Reducing Ton and Toff maximum values

Ed Harstead, Bill Powell
Nokia

100G-EPON

DML turn on time.

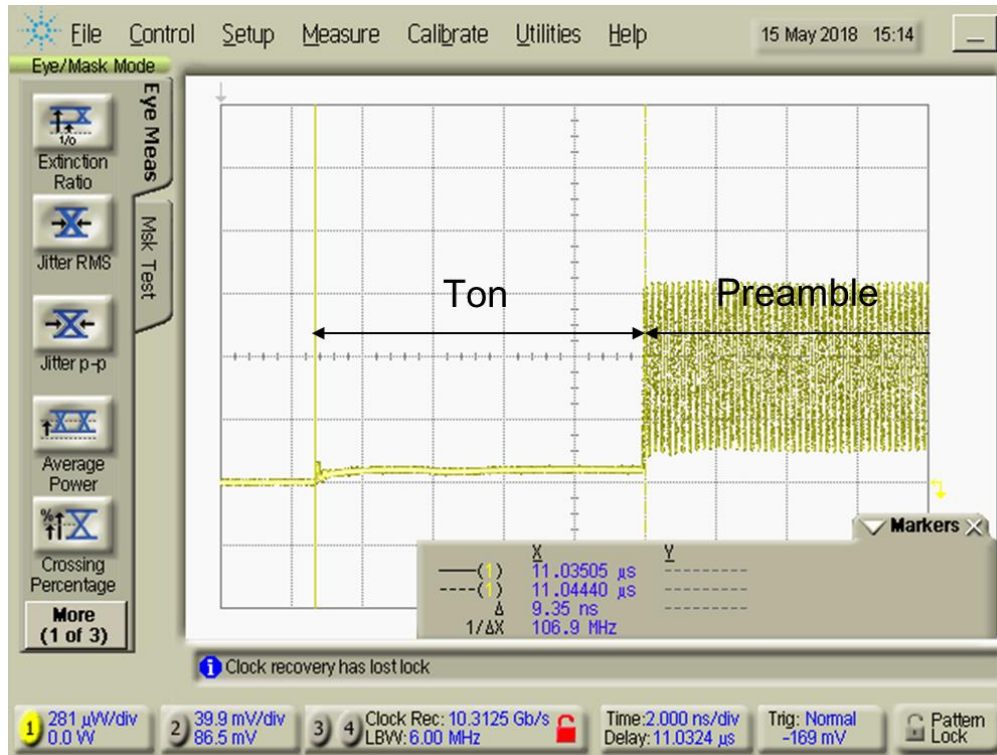
For example, Hanyub Lee: experimental result of 10G burst mode DFB laser. $T_{on} \sim 10$ ns.
